SUBJECT **I-30 East Project Update**

I-30 East Project Update

Preliminary TxDOT Concept Plans for I-30

General Comments on Preliminary TxDOT Concept Plans

TxDOT Preliminary Concept Plans

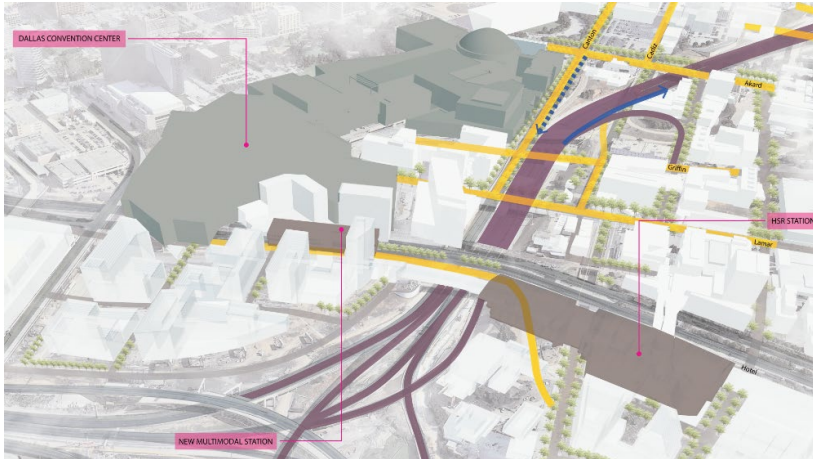
- Eliminates Cadiz connection across I-30
- Proposes cloverleaf style off-ramp to Griffin that eliminates development potential on that site
- Maintains/adds frontage roads designed for speed
- Bridges across I-30 do not adequately provide safe and comfortable multi-modal accommodations

The 360 Plan

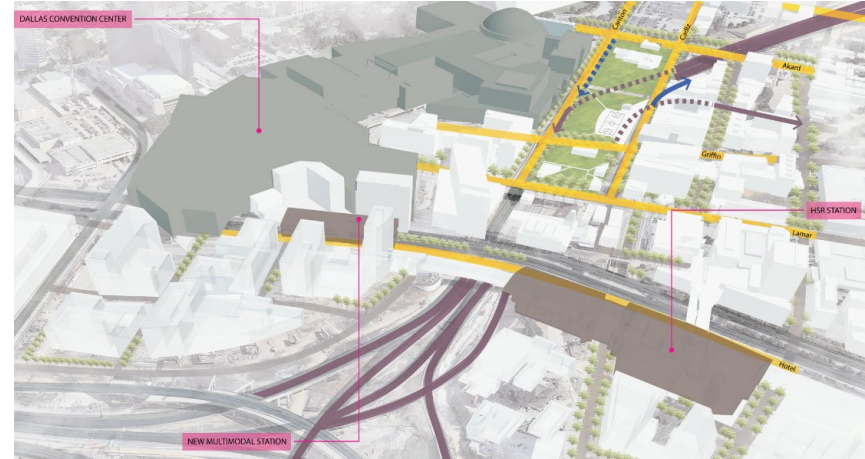
- Cadiz overpass across I-30 maintained
- Reimagines urban style off-ramps linking to reconnected city street grid and freeing land for development
- Frontage roads treated as complete streets which are friendlier to development, pedestrians, and connectivity
- Bridges across I-30 widened to provide safe, comfortable multi-modal connectivity

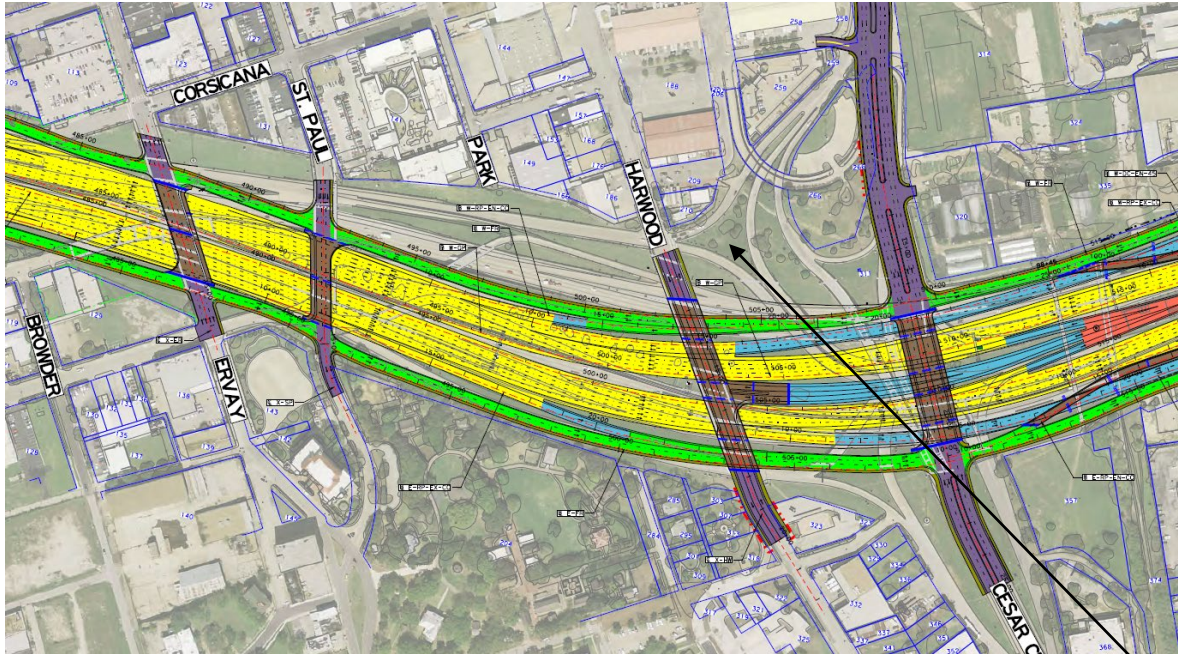
- TxDOT concept plans shut down some of the roads that connect the district
- Propose maintaining the street grids where possible
